I am the owner of 4 Pilgrim's Lane NW3 1SL and am writing to object to application 2012/5825/P relating to 8 Pilgrim's Lane. As an overall observation, I do not see how the new application has addressed the reasons for rejection of the previous application.

**Planning Application 2012/5825/P – 8 Pilgrim's Lane NW3**

Application No:  
2012/5825/P

Site Address:  
8 Pilgrims Lane  
London  
NW3 1SL

#### 1807 – British Library – detail from OSD 152 (Hampstead)

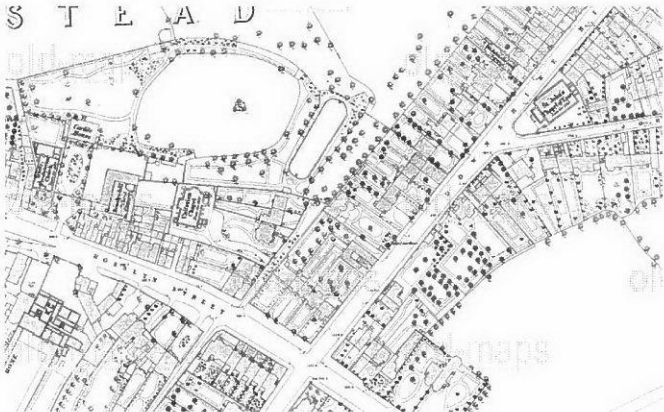
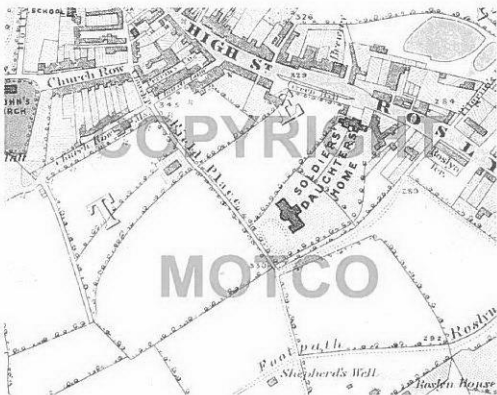
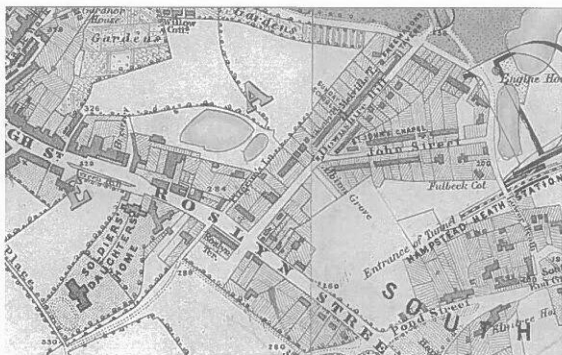
#### Historical evidence of water near the site of 8 Pilgrim's Lane

- 1802 map show tributary running from area of Kemplay road down to bottom of Pond Street
- 1879 maps show pumps around Unitarian Chapel including one on the current site of 11 Pilgrim's lane.
- 1862 map and others shows large ponds on the site of Carlisle House (bounded between the current Kemplay/Wiloughby/Denning/Pilgrim's Land)
- Water wells in Sidney Cottage, Cossey Cottage (currently #7 and #9 Pilgrim's Lane) are recorded as recently as in the book "Hampstead – Light and Shade"
- The existence of a pond "Red Lion Pond" at the corner of Downshire Hill and Rosslyn Hill is recorded in "Records of the Manors, Parish and Borough of Hampstead"
- Drinking fountains were located on Rosslyn Hill and water wells at the Brewery
